Addendum 1
TFM-082-23A M-166-22 Faculty of Medicine Audio Visual Upgrades

Copy: Andrew Kozak, EH **Project:** EH# 22405,
Memorial University of Newfoundland
Faculty of Medicine AV Systems

From: Romeo Labio **RE:** *TFM-082-23(A) Request for Open
Call - Addendum AV-01*

NOT FOR CONSTRUCTION
4 IN
PLOT SCALE CHECK 100mm

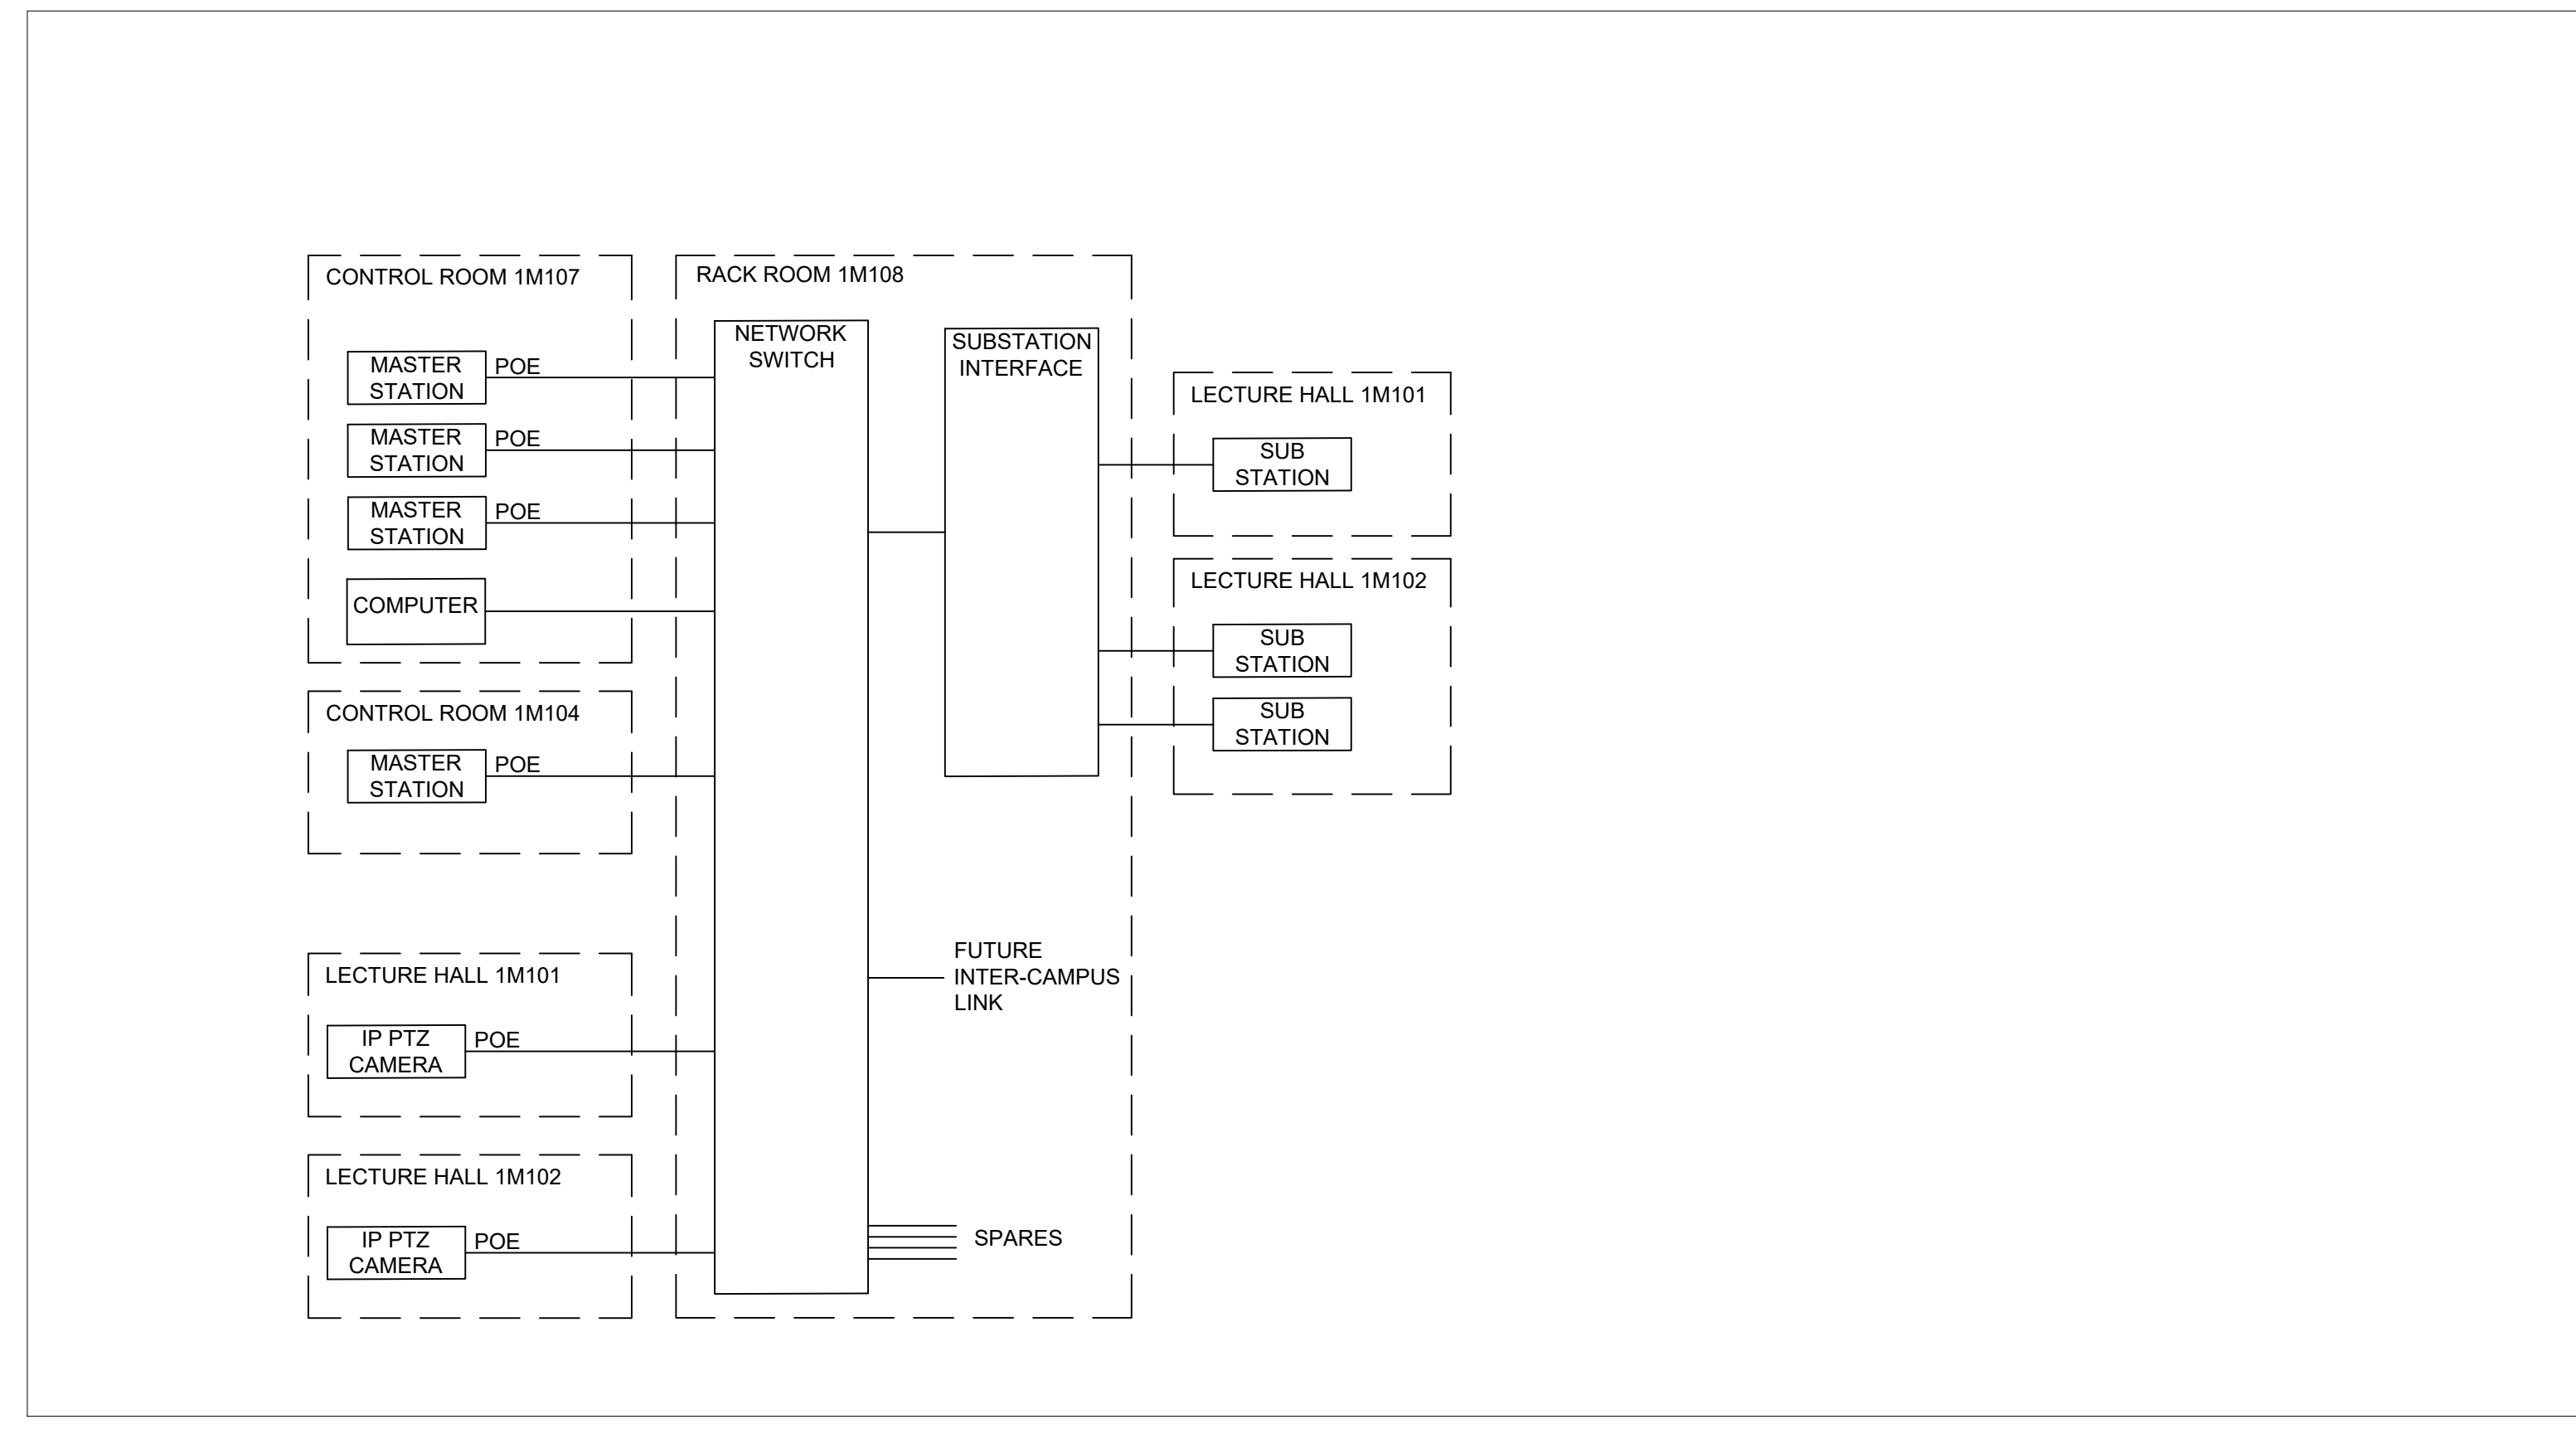
2. Section 2.13.3 Module B: Flat Floor Interactive Learning Room – Equipment
 - a. Provide (1) AVoIP multiviewer to be mounted in the equipment rack in room 1M104. This multiviewer shall be used for showing windowed content on the screen during video conferencing call.

- b. See attached functional drawing;
 - i. AV-602 to be deleted.
 - ii. AV-602 R1 to be added.
- c. The Amend equipment list to be added to the existing table:
